NUCLEAR REGULATORY COMMISSION

LaSalle County Station, Units 1 and 2

ACTION: Environmental assessment and finding of no significant impact; issuance.

Figure 1. Current and Proposed Temperature of Cooling Water Supplied to the Plant from the CSCS Pond Versus Time of Day Requirements

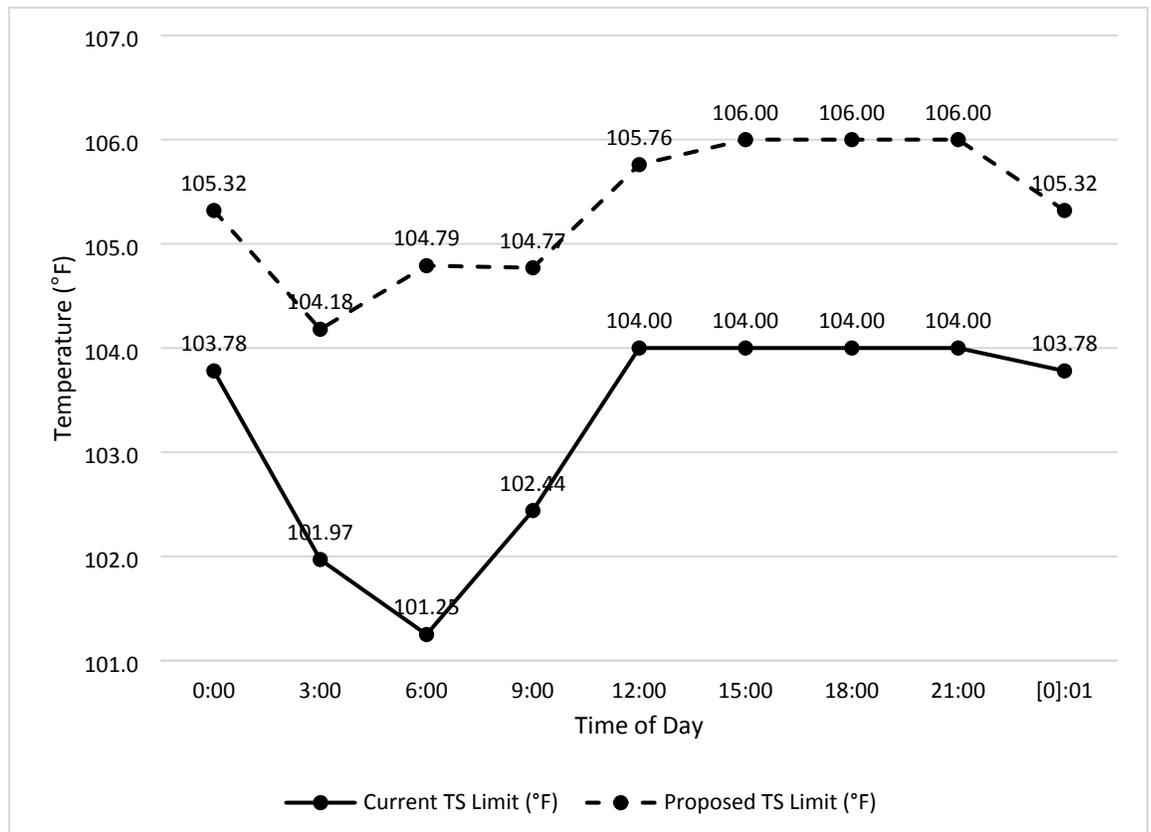
The proposed action would also modify the temperature curve associated with TS SR 3.7.3.1. This requirement currently states, “Verify cooling water temperature supplied to the plant from the CSCS pond is within the limits of Figure 3.7.3-1.” Under the proposed action, Figure 3.7.3-1 would be modified to specify new diurnal temperature limits. The revised TS temperature limits would continue to vary with the diurnal cycle and would continue to limit the maximum temperature of the UHS supplied to plant safety systems to below 107 degrees Fahrenheit ($^{\circ}$ F) (41.7 degrees Celsius ($^{\circ}$ C)), the design limit of the plant. The revised limits would increase the allowable maximum UHS temperature of cooling water by 1.54 to 3.54 $^{\circ}$ F (0.85 to 1.97 $^{\circ}$ C) as

compared to current limits and depending on time of day. Table 1 lists the current and proposed temperature limits, and Figure 1 depicts these limits graphically.

The NRC staff anticipates that thermal effects under the proposed action would be qualitatively similar to those described in the FSEIS. The primary difference under the proposed action would be an incremental increase in the likelihood in the summer that fish in the thermally affected portion of the cooling pond would experience thermal effects causally related to plant operation. This is because under the proposed action, Exelon could continue to operate LaSalle during periods of higher UHS temperatures when it would currently be required to shut down. However, because the UHS is a small
